## Appendix C. AGENCY AND PUBLIC COMMENTS

# Public Comments

**Project:** I-70 Floyd Hill to Veterans Memorial Tunnels NEPA and 30% Design  
**Meeting:** Clear Creek County EA Comment Coordination  
**Date:** December 17, 2021  
**Location:** Virtual – Zoom

Open Space Commission Map of Hidden Valley Open Space Park

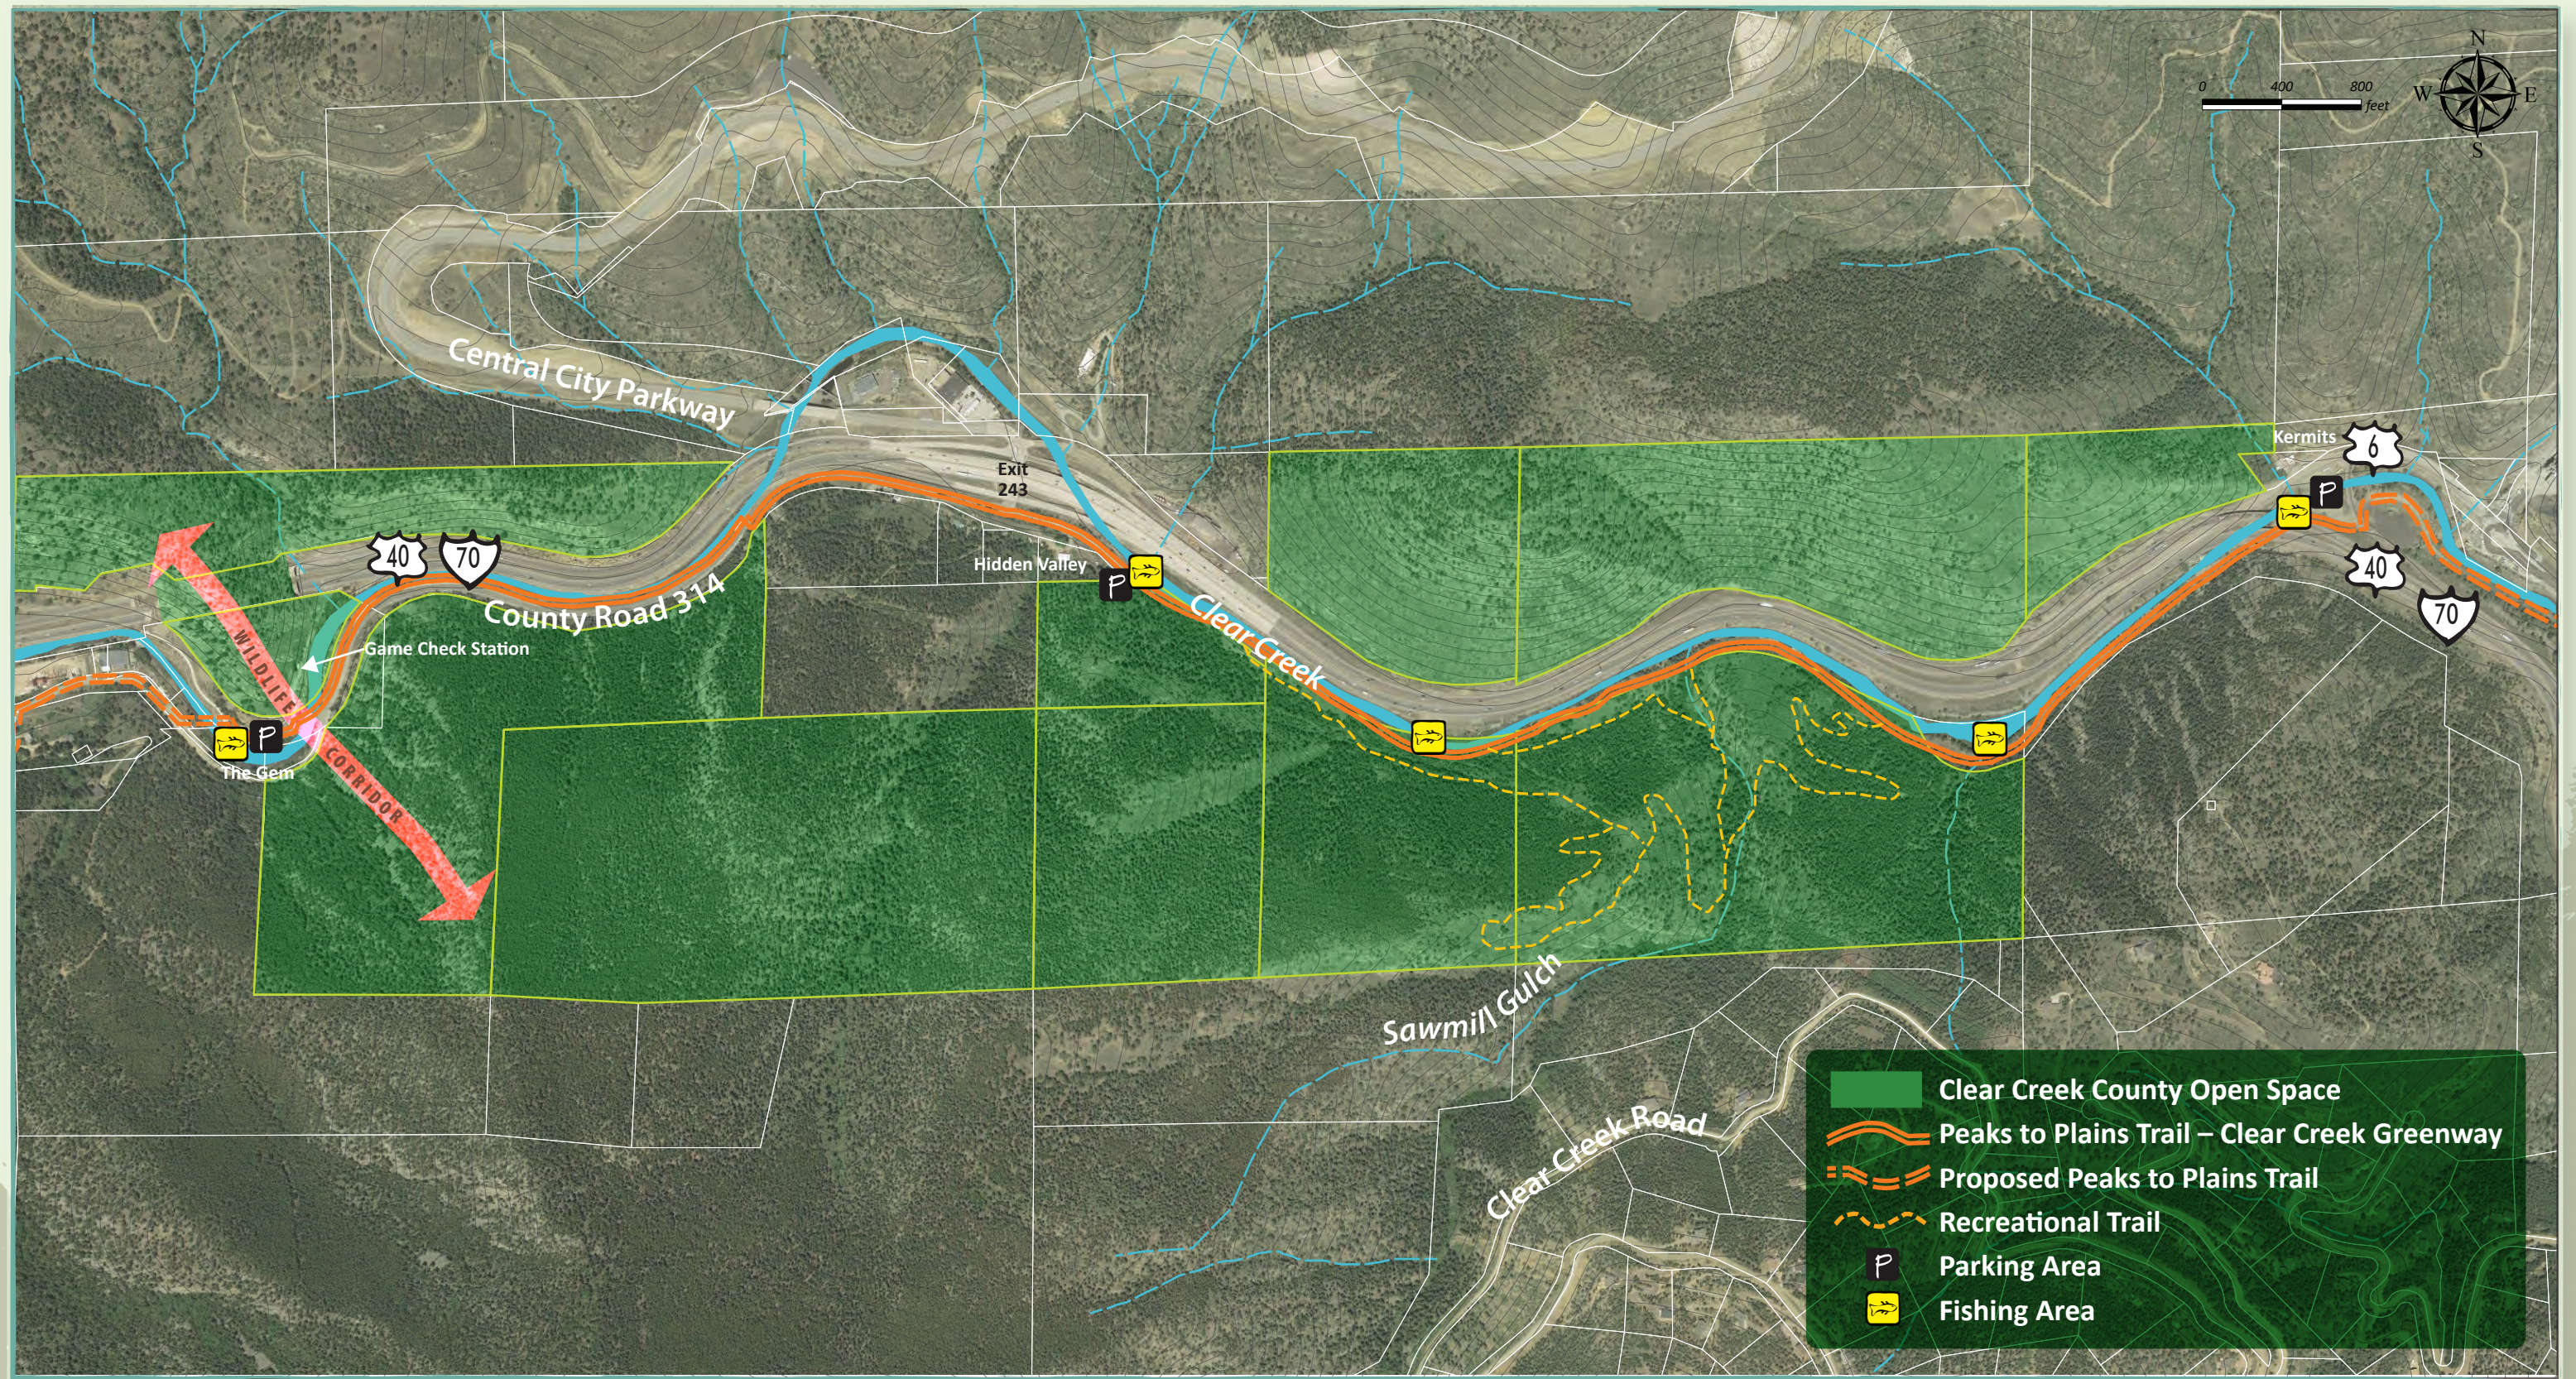
Clear Creek County continues to maintain that any alternative that includes the South Frontage Road option renders historical interpretation and recreational activities impossible in the public park owned by the County: 1) creating an adverse impact to an eligible historic resource under Section 106 of the National Historic Preservation Act (NHPA)(16 U.S.C. 470) and its regulations at 36 CFR § 800; and 2) constituting a violation of Section 4(f) of the U.S. Department of Transportation Act of 1966 (49 U.S.C. §303 and 23 U.S.C. §138) and its regulations at 23 CFR 774. (See attached comment letter from the Clear Creek County Open Space Commission as Exhibit 1.) In the South Frontage Road area, the project impacts to historical and recreational resources are inadequately documented in the EA. For example, the Table of Impacts and Mitigation on page 97 reveals that the protection of cultural and recreational resources during project construction is scant and should be further detailed and mitigated in the Final EA document.

The EA does not acknowledge that Clear Creek County secured the funding for and has indeed purchased the land and created a Development Plan for its Hidden Valley Open Space Park and recreation area in its January 2020 Hidden Valley Open Space Park Recreation Concept Development, prepared by ERO, which park should be protected under 4(f) (see attached Map of the Hidden Valley Open Space Park, included in the January 2020 ERO Report, as Exhibit 4). This park is a critical element to the Peaks to Plains Trail and is currently being constructed. The agencies allege the County’s Hidden Valley Park plan is merely “aspirational” (Appendix 15, 5.2 Para 2, pg 20). Moreover, the EA and Appendix 14 fail to recognize that Clear Creek County planned for this public park as far back as 1990 when the Scott Lancaster trail was first envisioned and the County first invested in design in 2012 with the Loris design project. We proceeded to purchase the contiguous parcels needed to create this public park and recreation area, over the past 20 years. One can tie the Clear Creek Greenway back to the 1990 Clear Creek County Inter County Non-Motorized Corridor Master Plan (1990 Plan) which laid out the initial path for the Greenway. The Planning Commission resolution approved the Clear Creek Greenway Plan in 2005, which references the 1990 Plan and other plans that included reference to the Greenway. Thus, the County was considering a non-motorized trail since 1990, and the Scott Lancaster Trail segment was the first to be built. This led to County land purchases along this segment, which resulted in the County owning the land that contains the trail corridor. There is no doubt that the County’s purchase of this real estate was intended to create the publicly owned park area that now exists adjacent to Clear Creek along the Clear Creek Greenway, with planned improvements such as: designated Clear Creek access points, pathways and stepping stones to water surface, trail and wayside designs and pull-offs with benches, and improvements to connectivity to the east in the Floyd Hill area.
